Model	DF61 (PYRENEES)	Volt/Hz	Date of Modification	Serial Number
Modified Article	Parts Catalog			
Reason for Modification	Parts Catalog Correction

Model: DF61	Date: 30-Jun-96	No.: 6
-------------	-----------------	--------

MB Correction

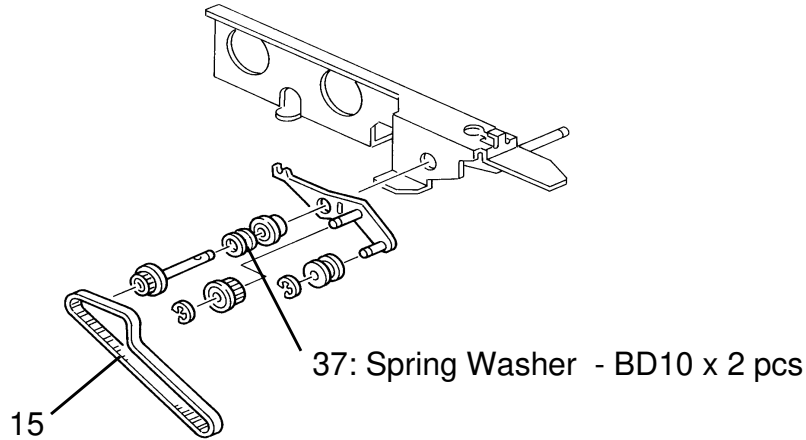
Please correct your parts catalog as follows:

Incorrect P/N	Incorrect Description	Correct P/N	Correct Description	Parts Catalog	
				Index No.	Page
A5482171	Paper Feed Shaft	A5481271	Separation Roller	9	5

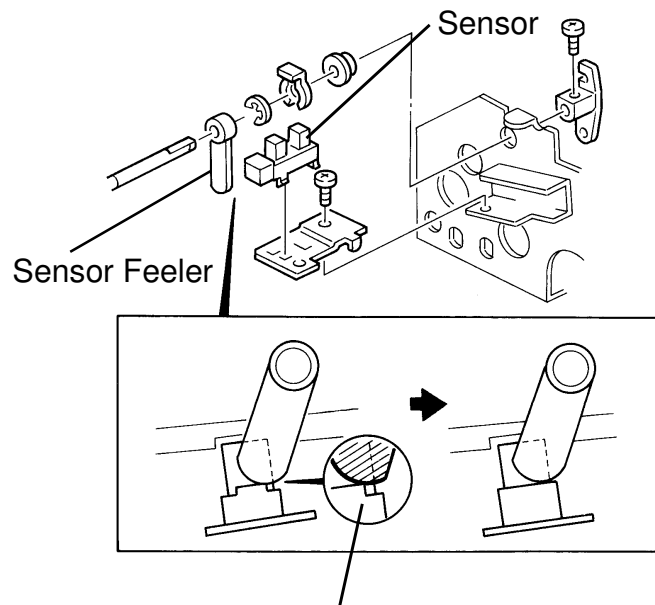
The shape of the photointerruptor has been changed as shown below to prevent the original sensor feeler from being caught by the notch at the edge of the sensor.

The feeler may be caught by the notch at the edge of the sensor.

Old P/N	New P/N	Description	Q'ty Used	Inter-changeability	Parts Catalog	
					Index No.	Page
AW02 0021	AW02 0075	Photointerruptor	1 → 1	X/O	9	7

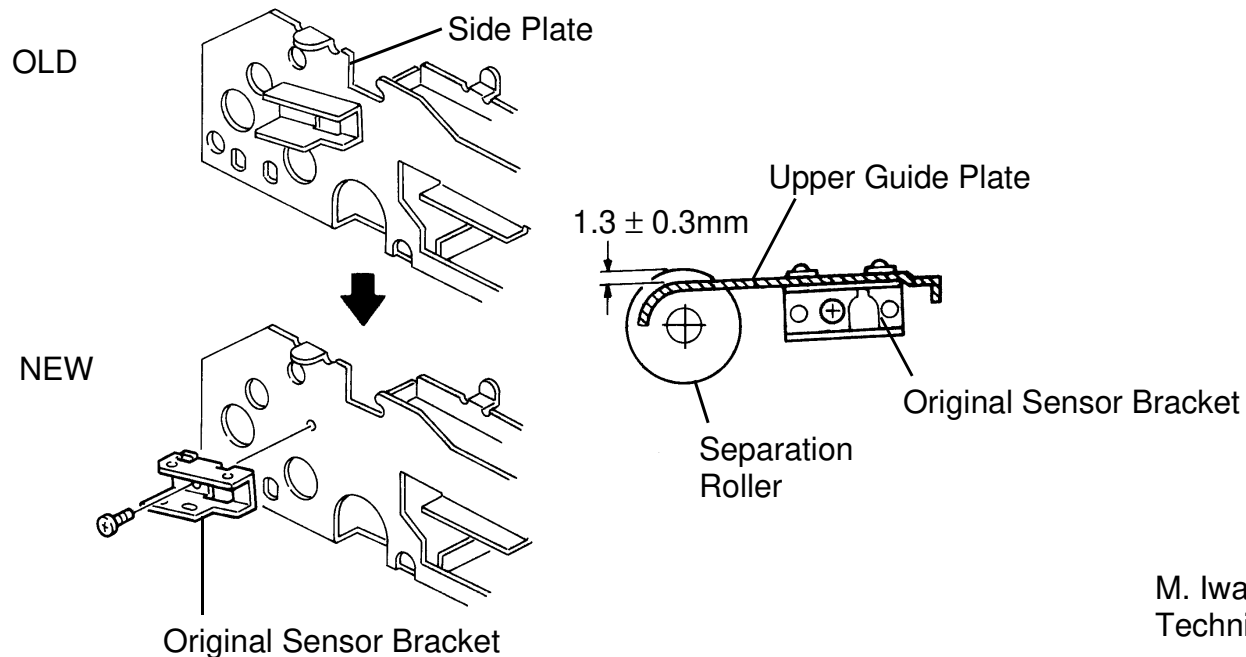
The original sensor bracket has been separated from the side plate as shown below.

Old P/N	New P/N	Description	Q'ty Used	Inter-change-ability	Parts Catalog	
					Index No.	Page
	A548 1127	Original Sensor Bracket	0 → 1

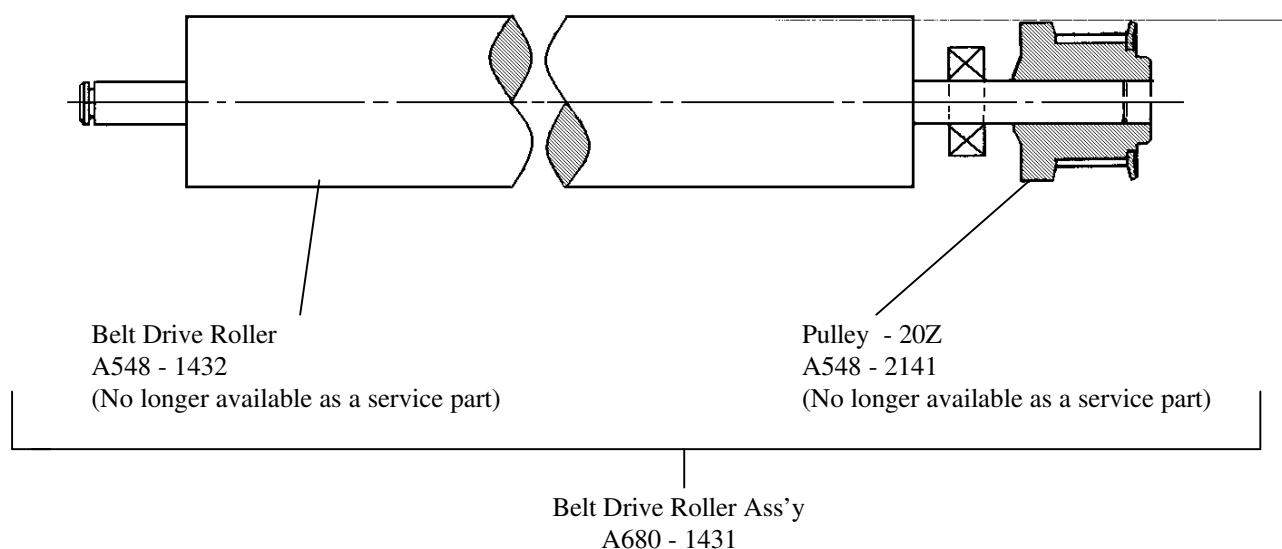
The individual part numbers for the belt drive roller and the timing pulley - 20Z are listed in the parts catalog, but the roller shaft is actually press-fit into the pulley on the production line. The pulley - 20Z cannot be installed on the roller shaft in the field.

Old part number	New part number	Description	Qty	Int	Page	Index	Note
A548-1432		Belt Drive Roller	1		9	1	
A548-2141		Timing Pulley - 20Z	1		9	13	
	A680-1431	Belt Drive Roller Ass'y	1	X/O	9	1

A part number has been assigned for the belt drive roller assembly instead of for the belt drive roller and the timing pulley.

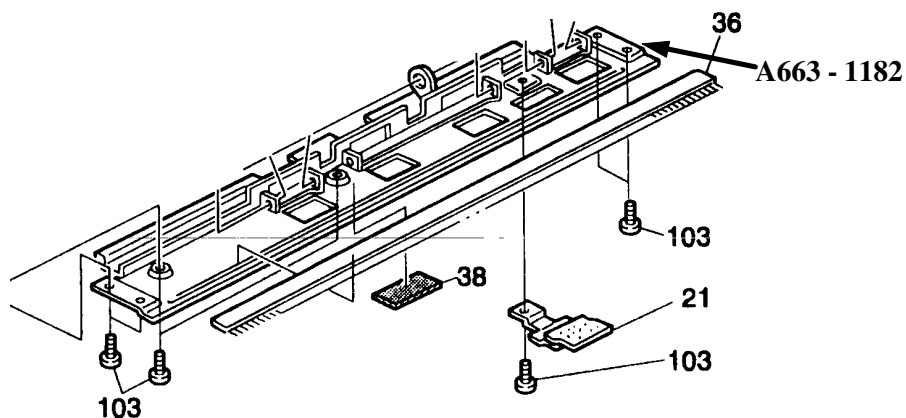
A part number has been assigned for the Base Bracket - Original Feed.

Old part number	New part number	Description	Qty	Int	Page	Index	Note
	A663 - 1182	Base Bracket - Original Feed	1	—	5	40

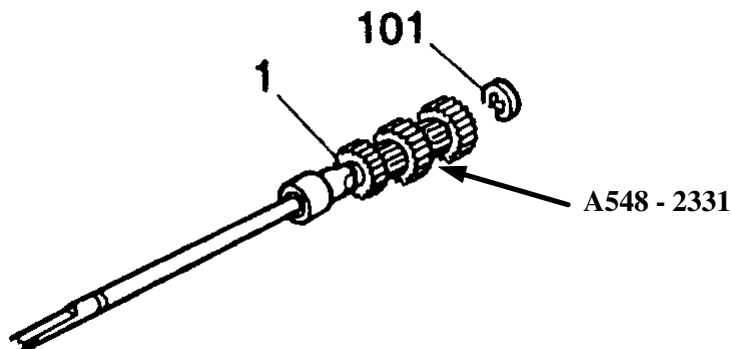
The part number #A548 - 2331 listed on page 5 (Index 1) is for the entire assembly unit.
The description of the Index 1 has been corrected as follows.

Note: A part number has not been assigned for the individual part.

Incorrect Description	Correct Description	Page	Index
Gear - 23Z	Drive Gear Ass'y	5	1

Page 12

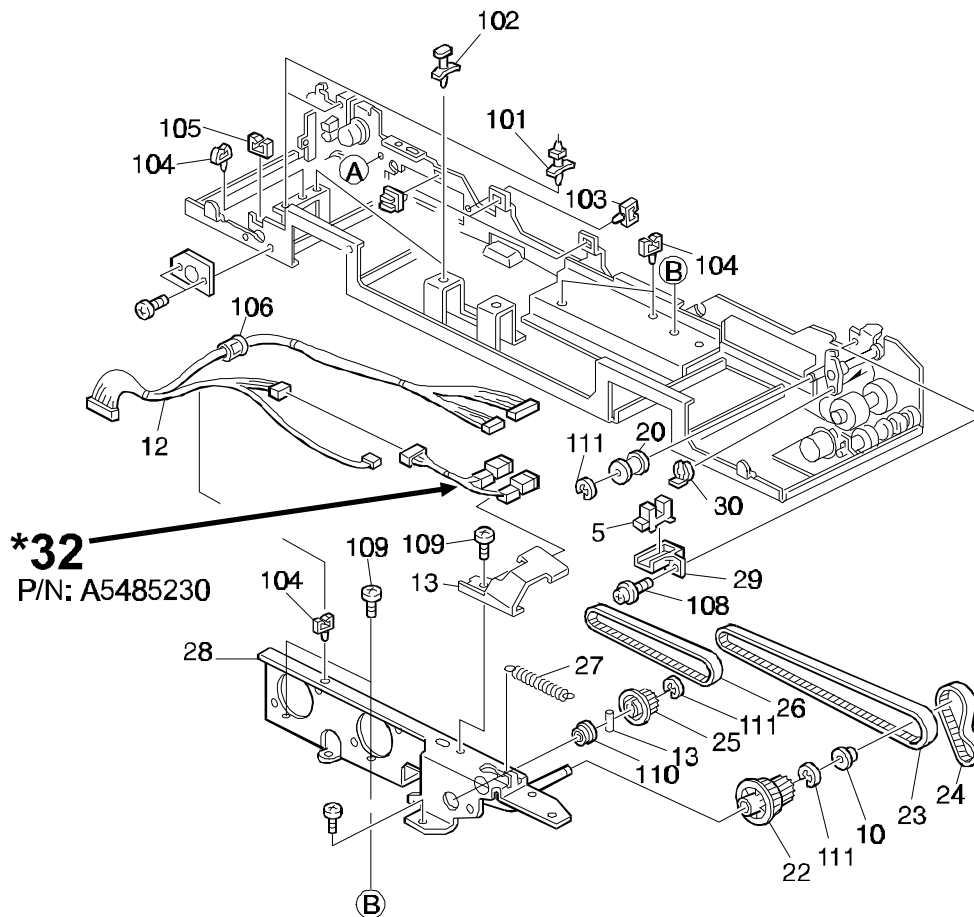
The index number was missing inside the following illustration.
Please add the following number as shown below.

New part number	Description	Qty	Page	Index
A548 5230	Indicator Harness	1	12	32

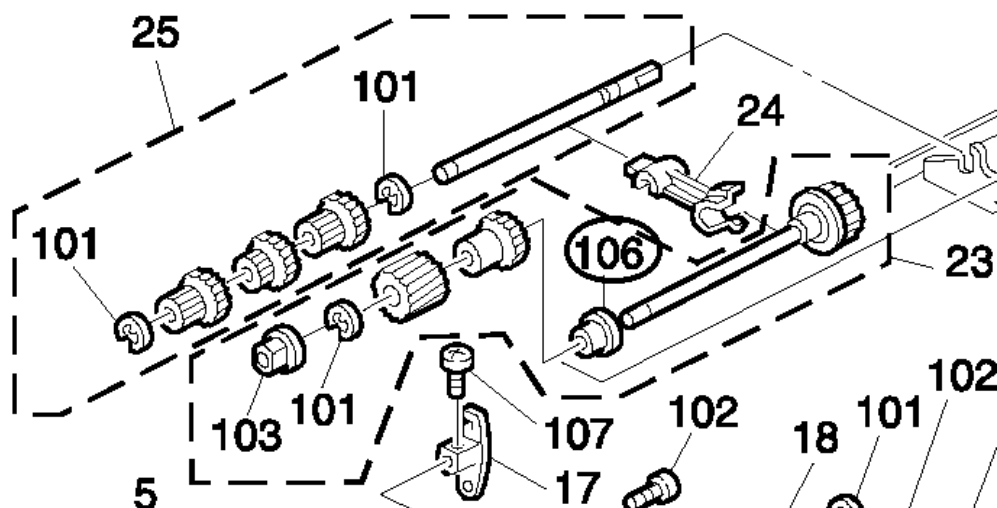
Old part number	New part number	Description	Qty	Int	Page	Index	Note
07403906	A2323564	Ball Bearing – 6x15x5		O/O	7	106

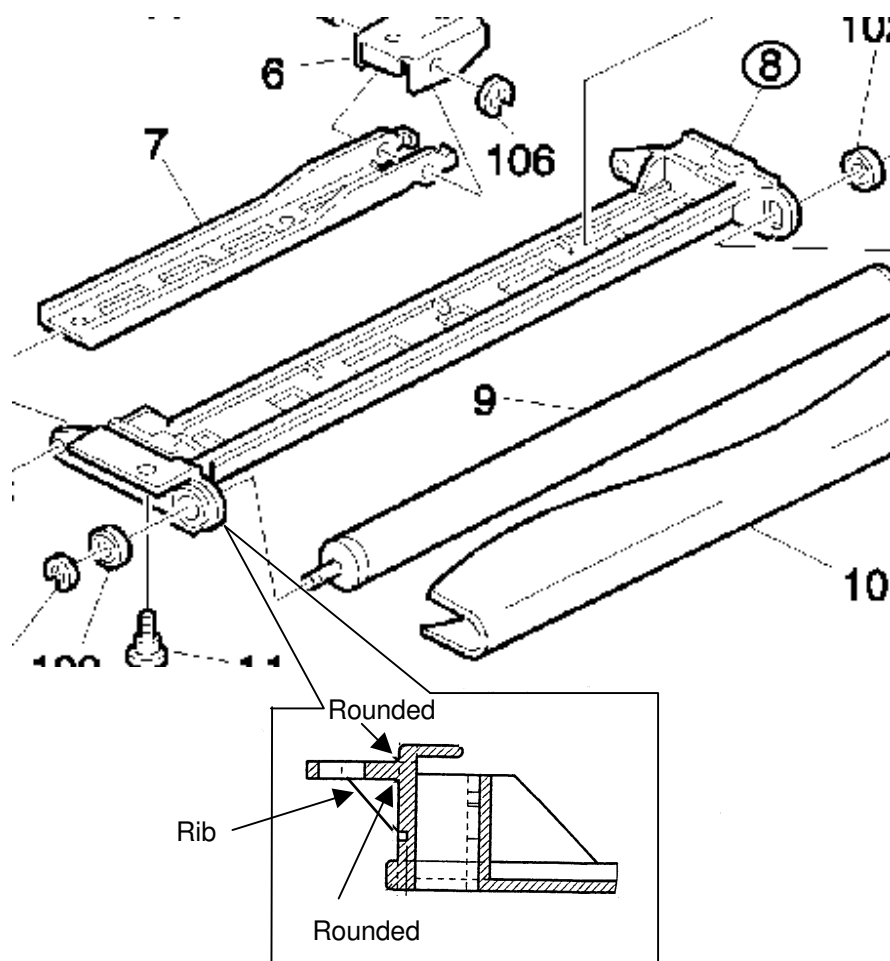
The part of the transport stay which comes in contact with the surface of the transfer belt has been changed from a smooth surface to a rough one to prevent noise.

The part of the stay, shown in the illustration, has been rounded and a rib has been added to prevent breakage due to stress.

Old part number	New part number	Description	Qty	Int	Page	Index	Note
A5481422	A6631422	Transport Stay	1 - 1	X/O	9	8

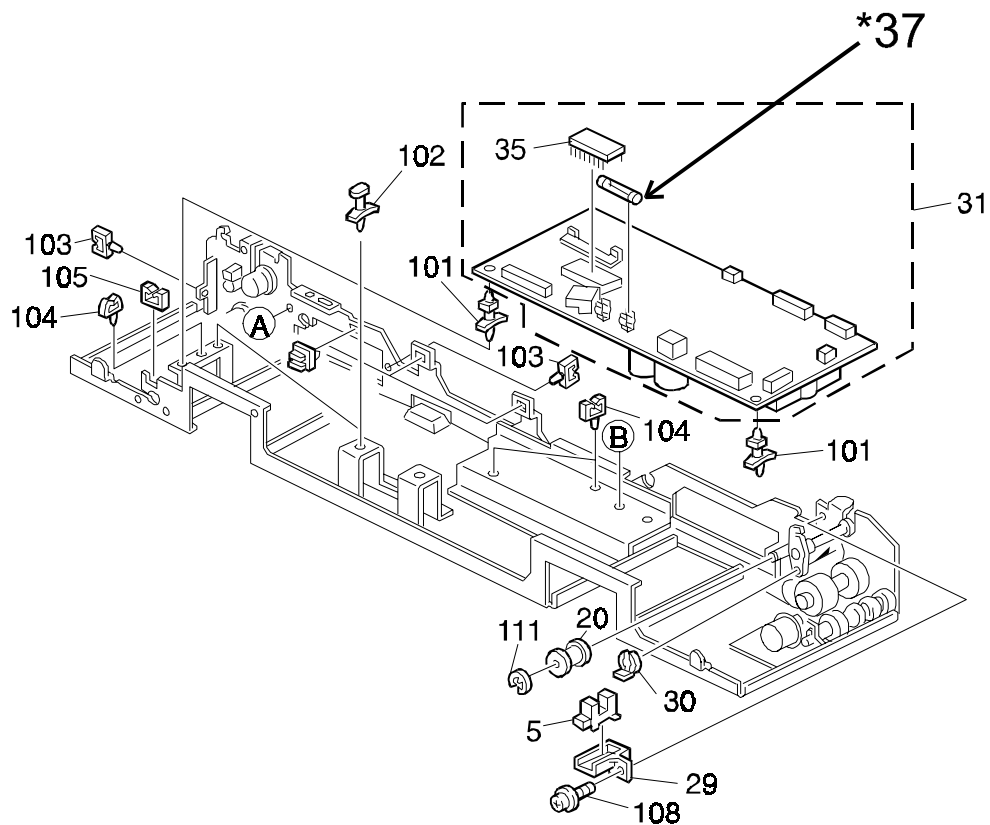
Please add the following part to your parts catalog.

New part number	Description	Qty	Page	Index
1107 0750	Fuse - 3.15A 250V	1	13	37

Page 13

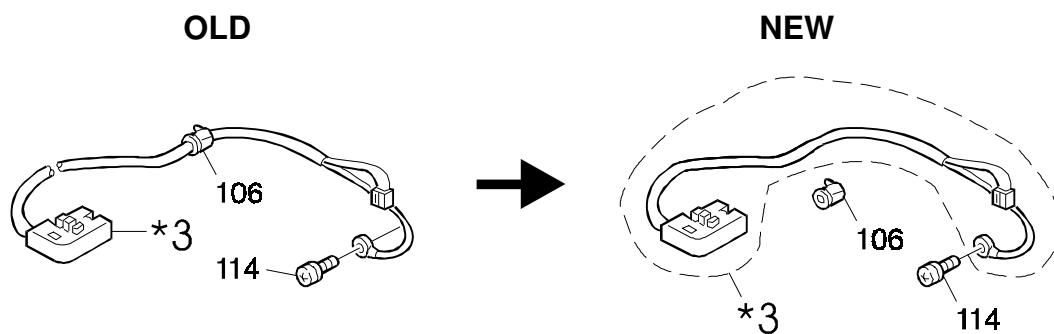
Please correct your parts catalog as follows:

Old part number	New part number	Description	Page	Index
A548 5281	A548 5280	Interface Harness	13	3

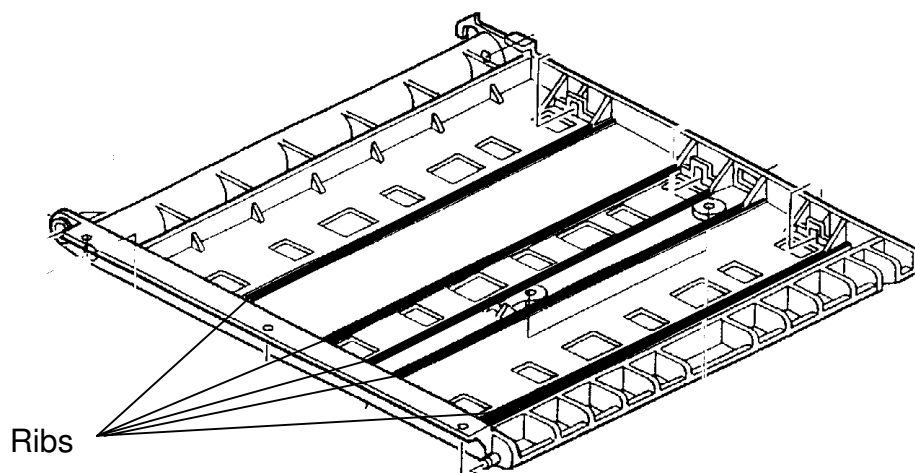
To prevent the transport base plate from being bent, the height of the five ribs on this part has been increased by 15 mm.

If the transport base plate is bent, an original jam may occur as a result of the transport belt stopping.

Old part number	New part number	Description	Qty	Int	Page	Index	Note
A5481412	A6631412	Transport Base Plate	1-1	X/O	9	4
